AGENDA
PLANNING AND ZONING COMMISSION WORK SESSION
City Hall, 385 South Goliad, Rockwall, Texas
Council Chambers
February 26, 2019
6:00 P.M.

Project Plan Review History

Project Number	Z2019-003	Owner	ROCKWALL, I S D	Applied	2/15/2019	LM
Project Name	901 W. Yellowjacket Ln.	Applicant	SET ENGINEERS	Approved		
Type	ZONING			Closed		
Subtype	SUP			Expired		
Status	Staff Review			Status

Project No.:	35533
Issued:	FEBRUARY, 2019
Drawn By:	CAD
Checked By:	MJG
Scale:	AS SHOWN
Sheet Title	OVERALL SITE PLAN
C0.01	Sheet Number

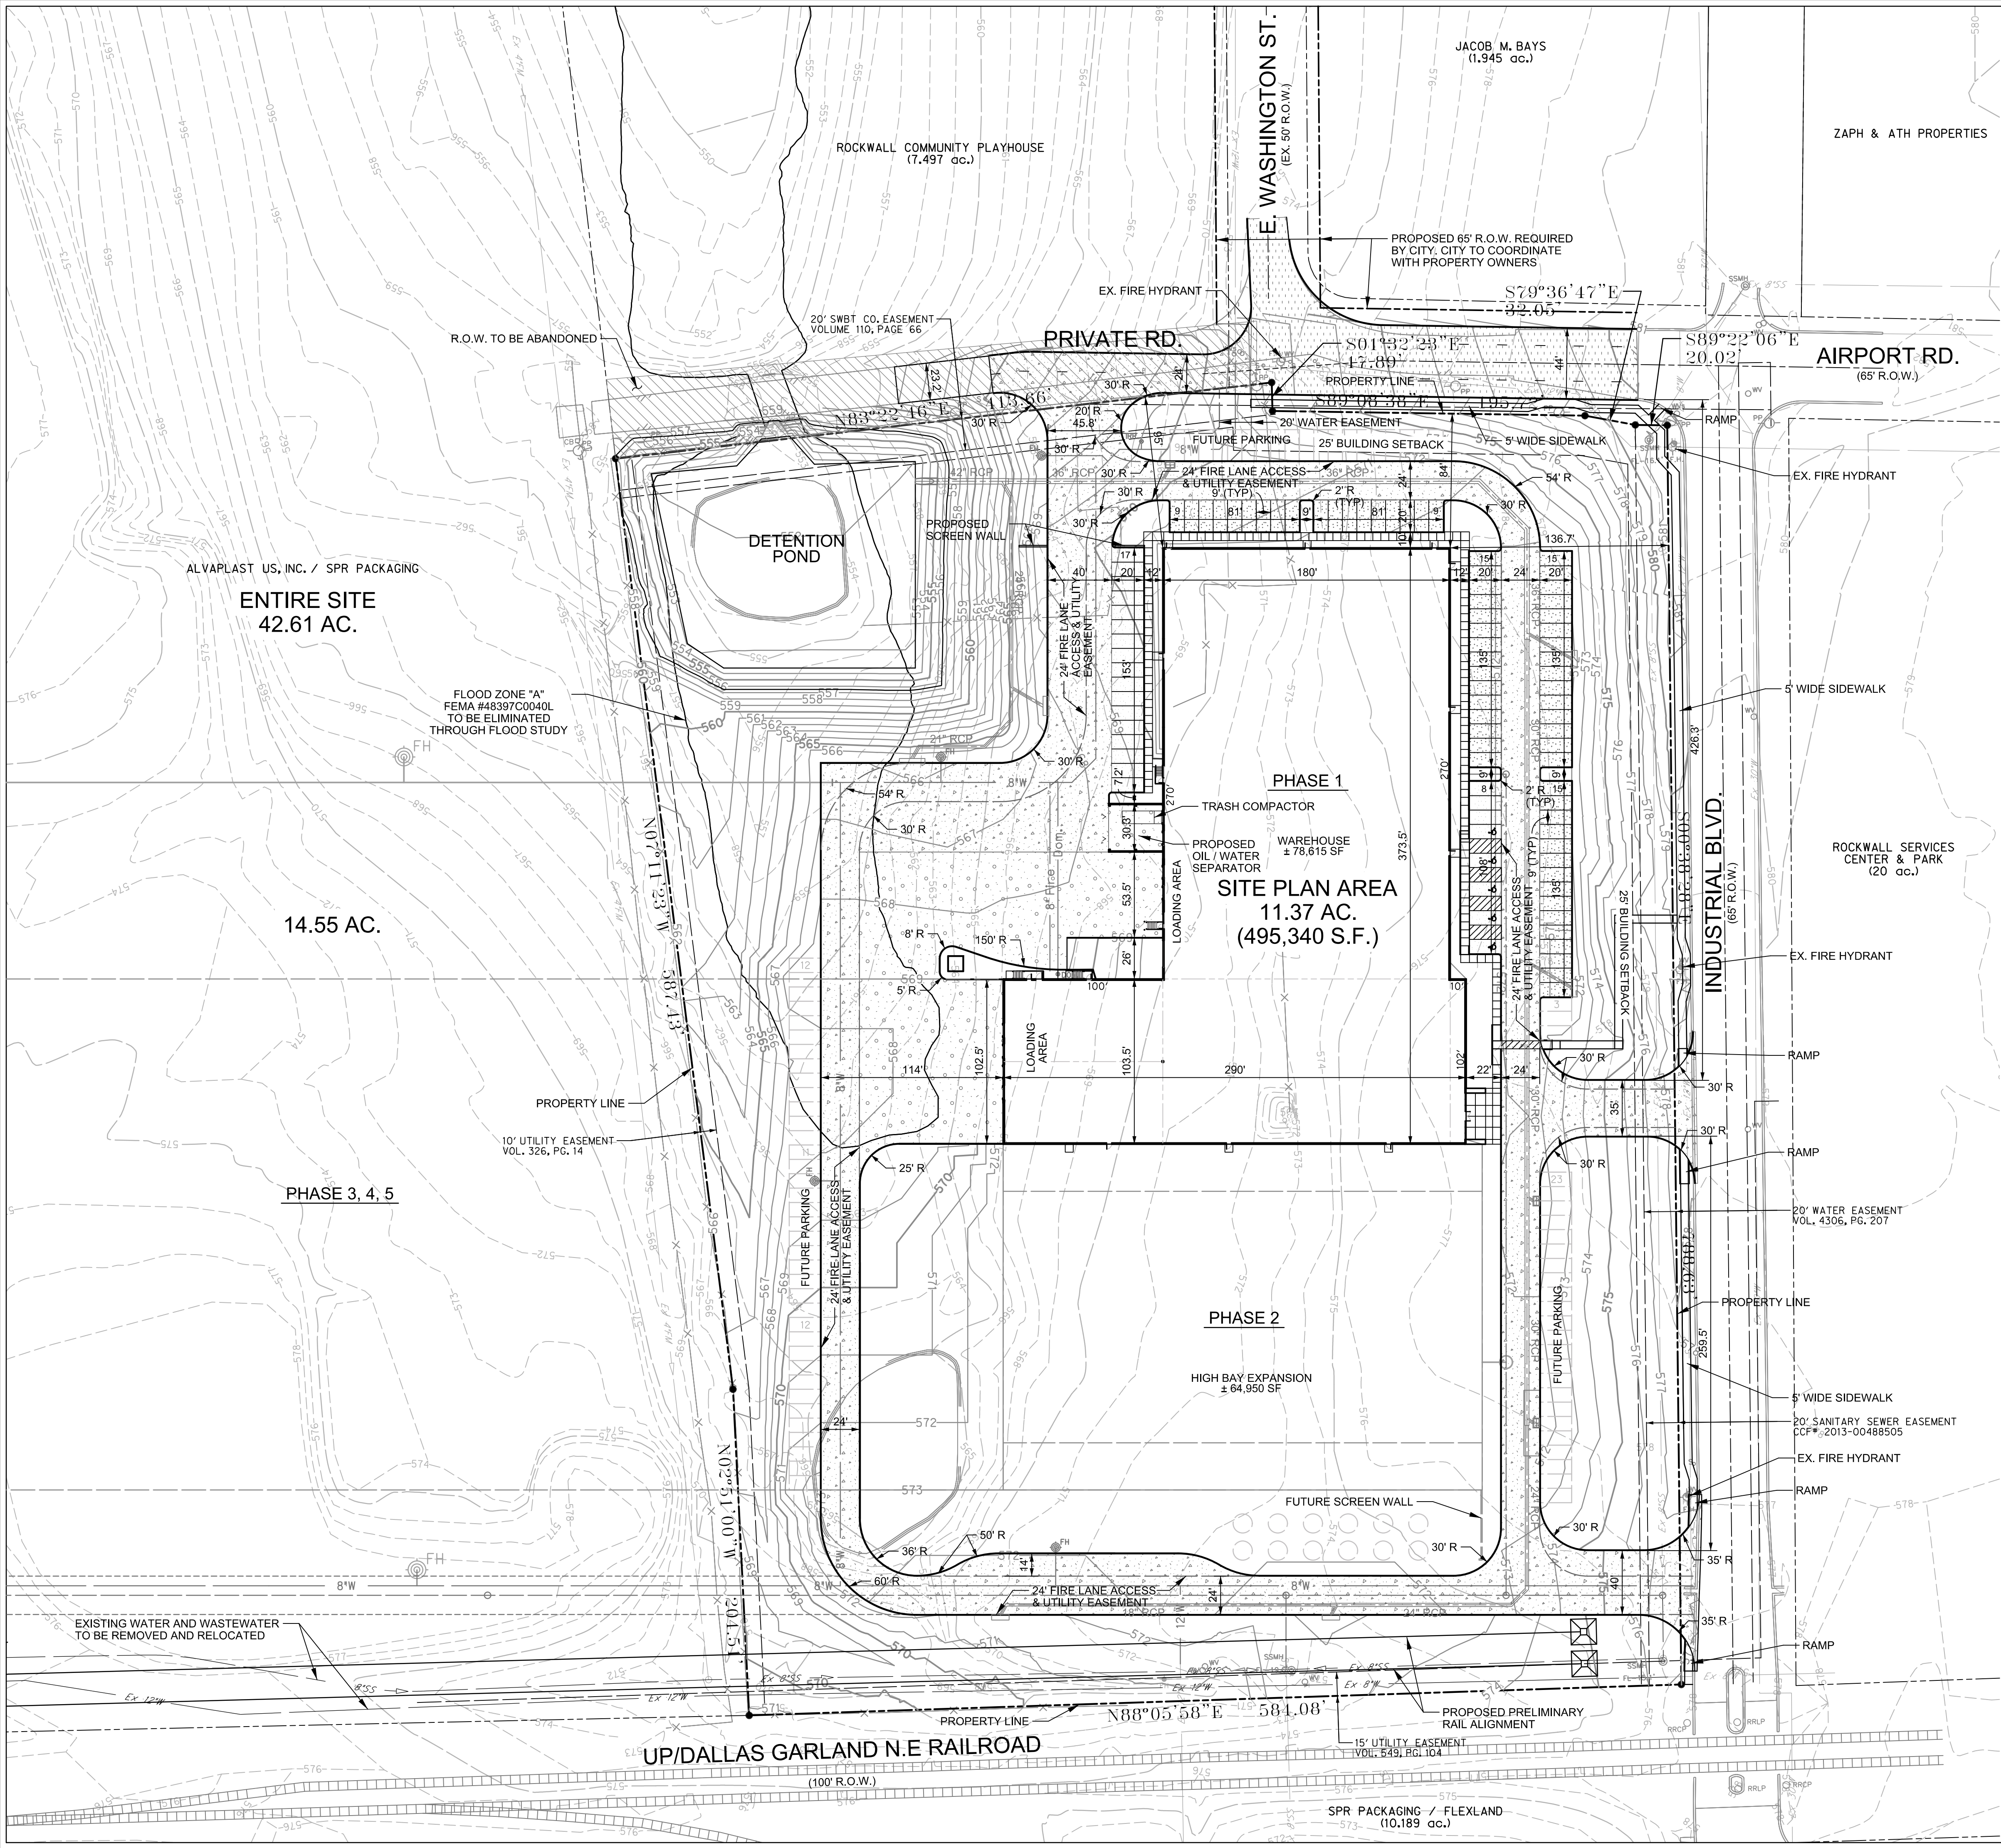
1. The Phase 1 building wall panels will be 46' feet in height. There is no problem with the development of the Phase 1 building with these panel heights. However, the Phase 2 will have an Extruder Area that will be a total of 120' tall. We will be submitting a Special Use Permit to receive approval to go to this height. It should be noted that we were granted a Special Use Permit for the height of the Extruder Area for the existing building to 75'.

1. Due to the size of this building and its additional phases, the building will not meet current articulation standards. The tops of the wall panels for the Phase 2 portion of the project will be saw-tooth to match the existing building. There will be a massive entrance on the east side of the project, which will separate Phase 1 and Phase 2, where exterior stone will be utilized. A large glass facade will also accompany this area of the building. The Phase 1 building will have limited off-
